ADDENDUM #3

Project	Nelson H.S. Renovations	Project No.	2323
Location	4181 New Street, Burlington, Ontario	Date of Issue	2024 05 31
Owner	The Halton District School Board	File	2323/7.1.3

This Addendum forms part of the Contract Documents and amends the original Drawings and Specifications, dated 2024 05 13, as noted below.

Drawing Title:
**CONCEPTUAL
IMPLEMENTATION AND
PHASING PLANS**

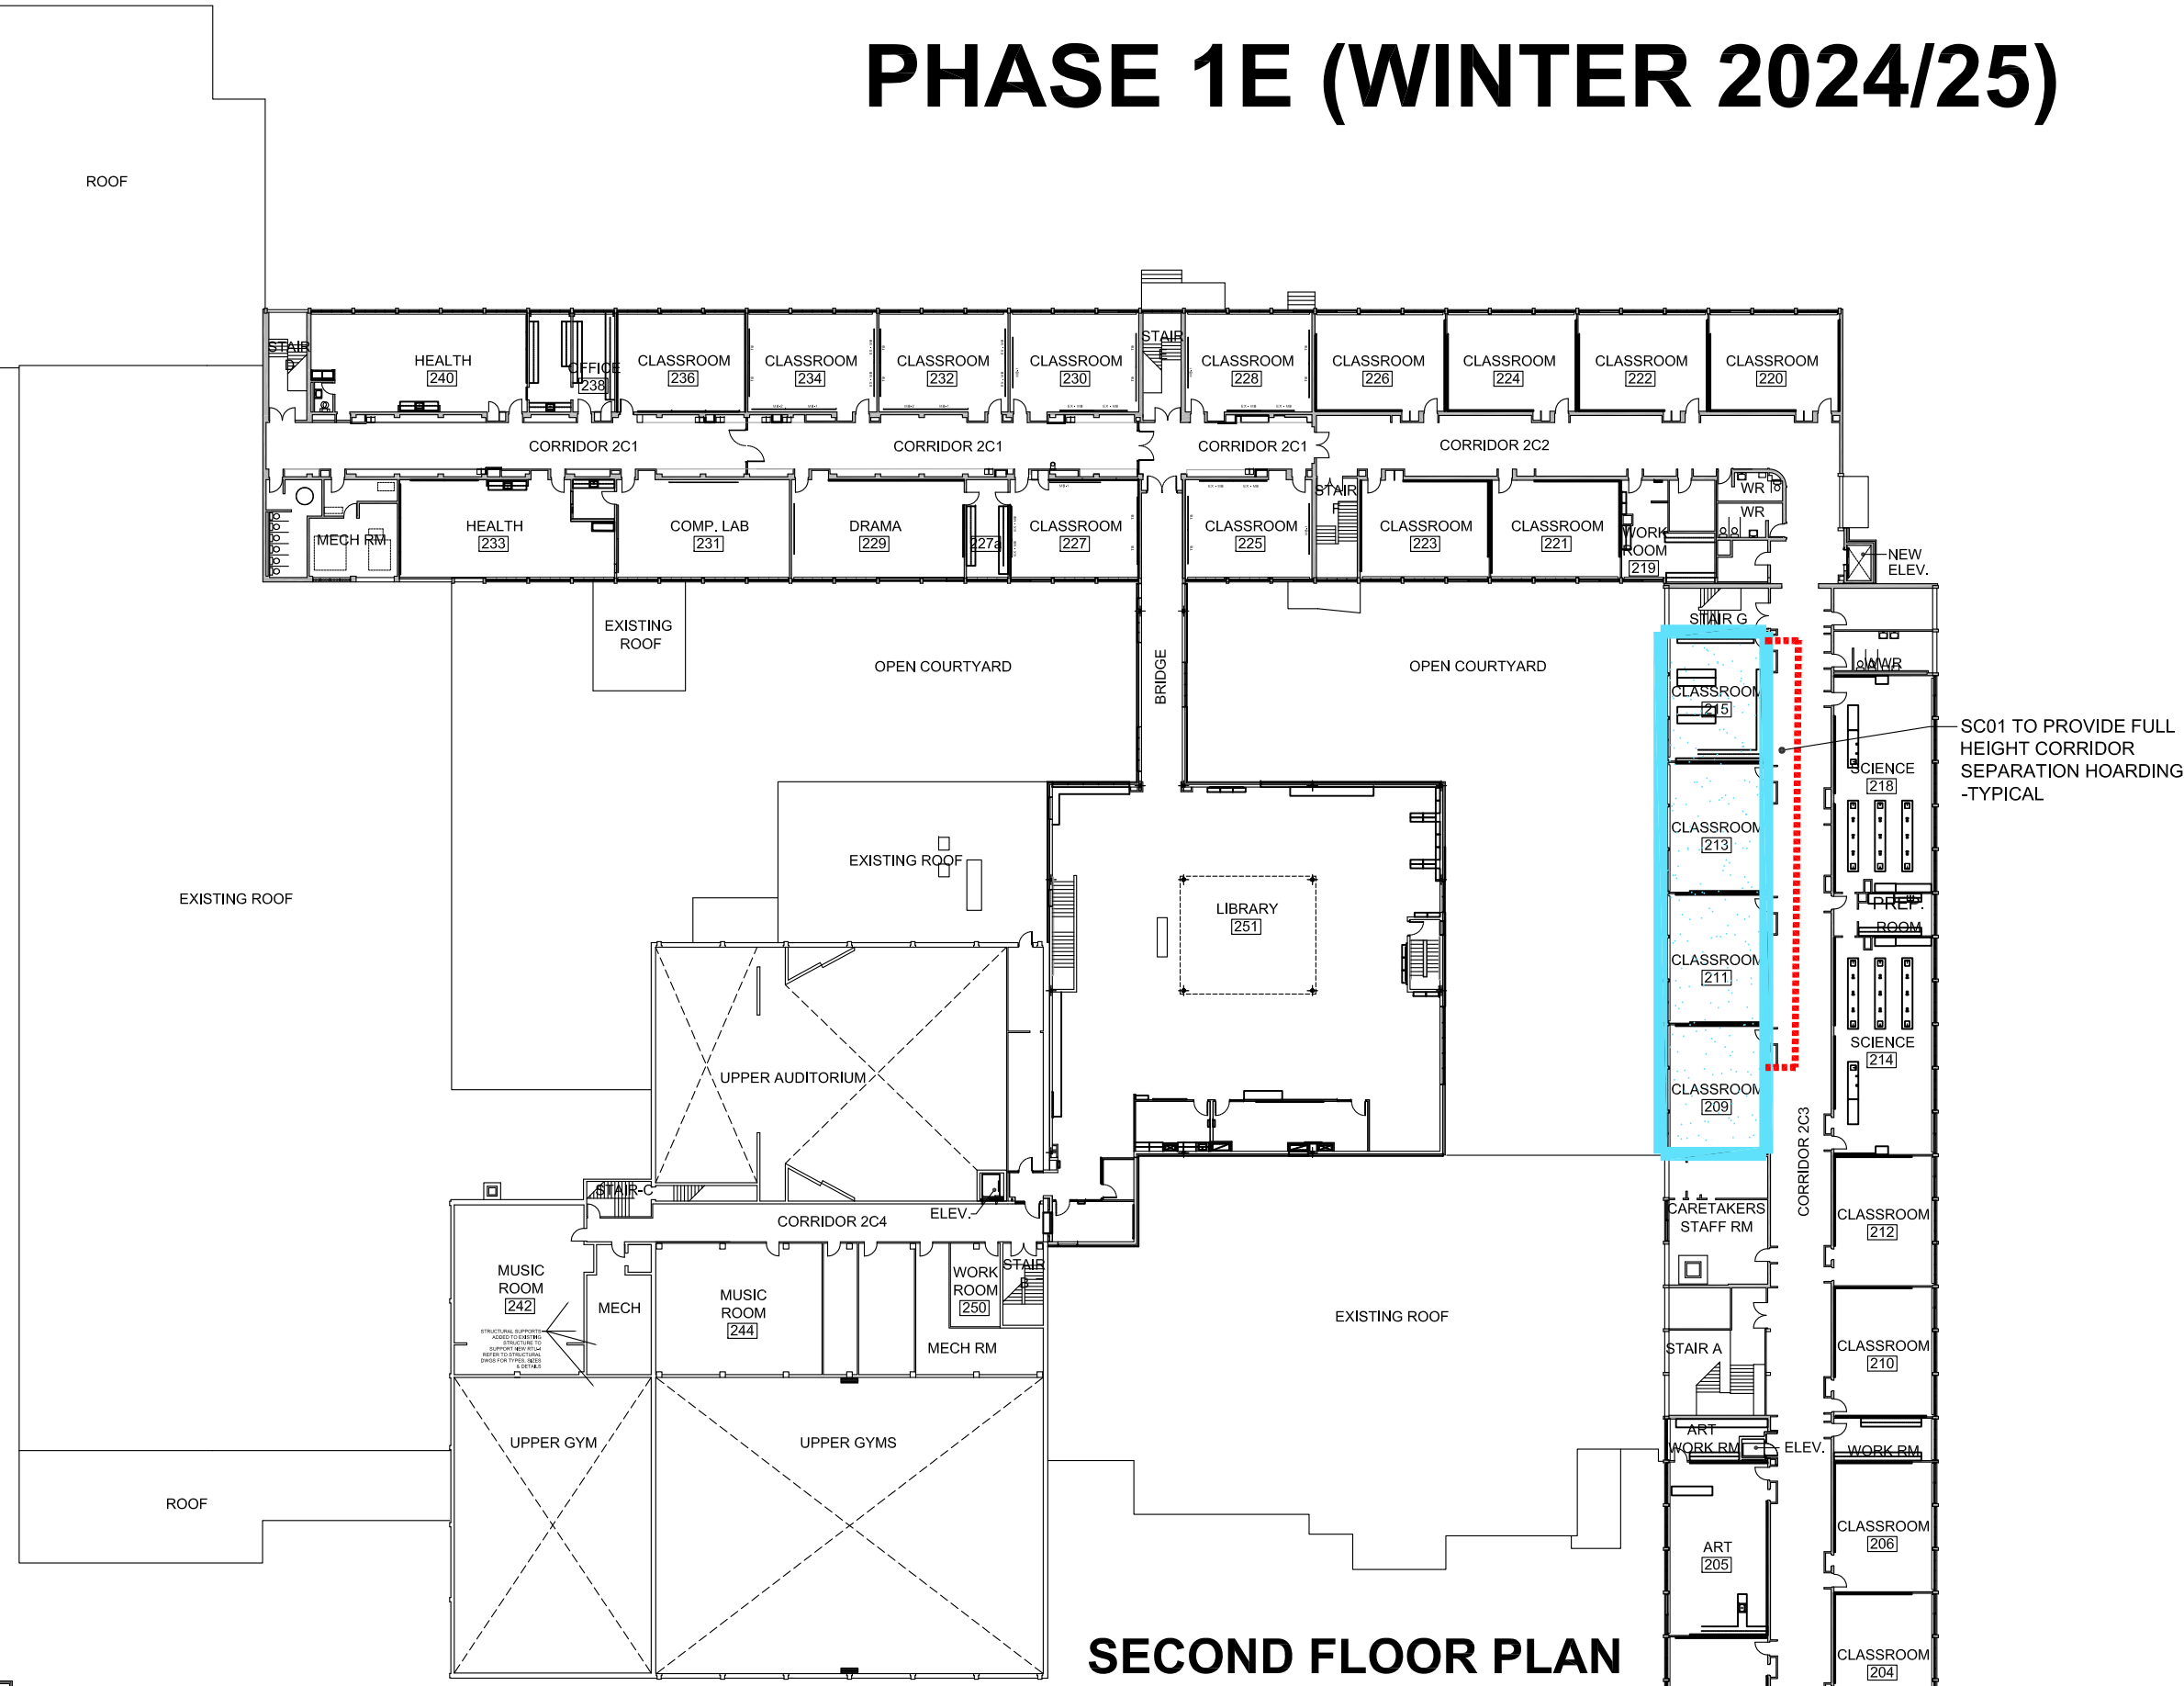
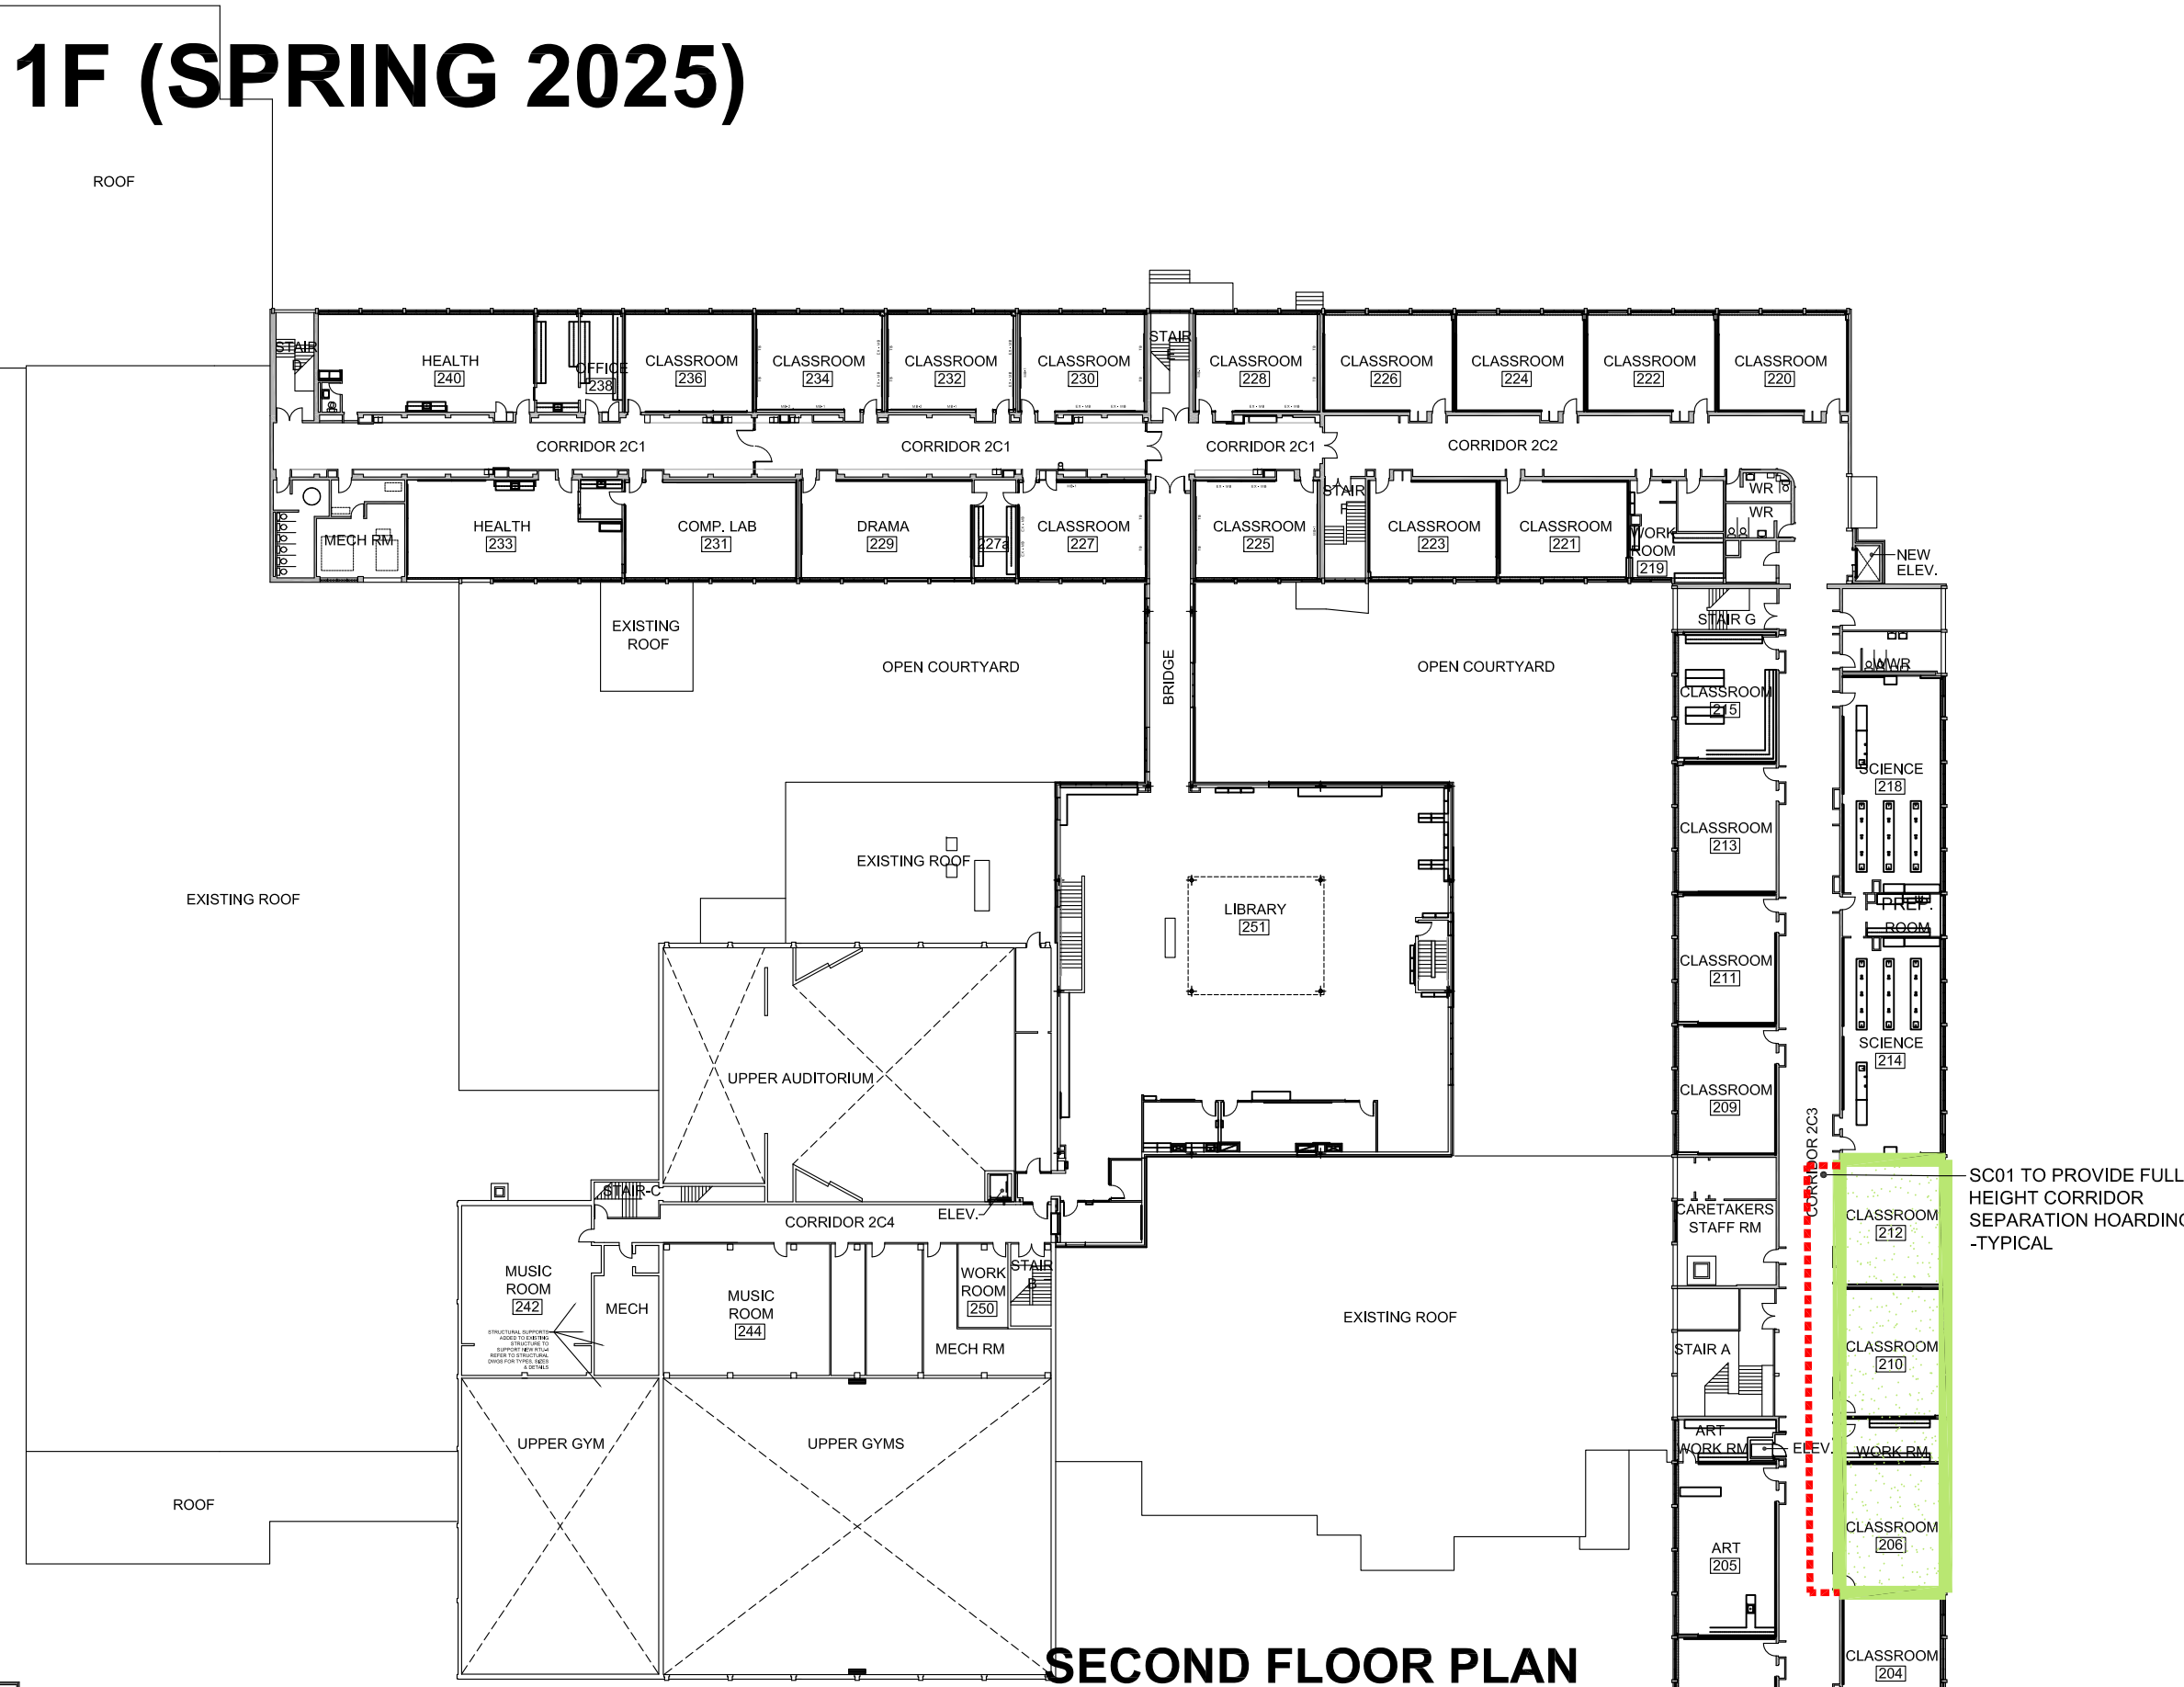
A3-1 DRAWING A104 CONCEPTUAL IMPLEMENTATION AND PHASING PLANS (issued)

- .1 Add missing drawing
